Docket Item #15
Development Special Use Permit #2015-0006
TMP Special Use Permit #2015-0094
Mark Center Plaza IA – Building 5
Institute for Defense Analyses (IDA) - Extension

| Application | General Data | |
|--|----------------------------------|--------------------|
| Project Name: Mark Center Plaza IA - Building 5 | PC Hearing: | September 1, 2015 |
| Location: 4880 Mark Center Drive | Zone: | CDD#4 |

| Purpose of Application |

Graphic #1.

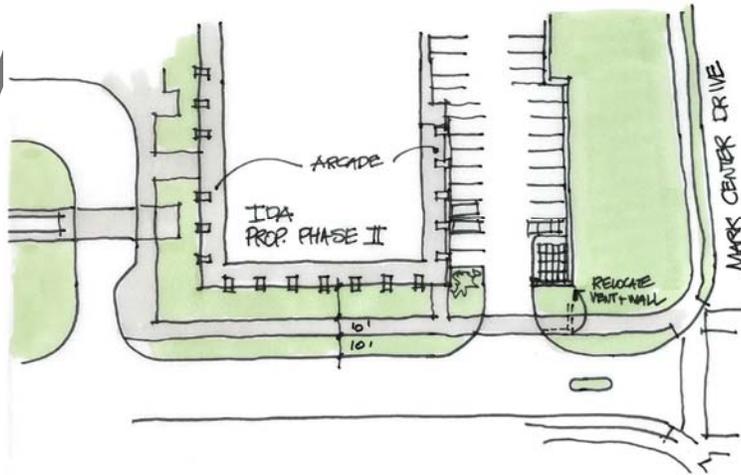
22. Provide the following building refinements to the satisfaction of the Director of P&Z:
 - a. Condition deleted. (City Council)
 - b. Relocate the parking garage air intake and stone wall screen element at least as far from the curb as the proposed Phase II building façade, in order to accommodate an ample width for pedestrian circulation and landscaping, as depicted in graphic # 2. (P&Z) (DSUP #2007-0027)
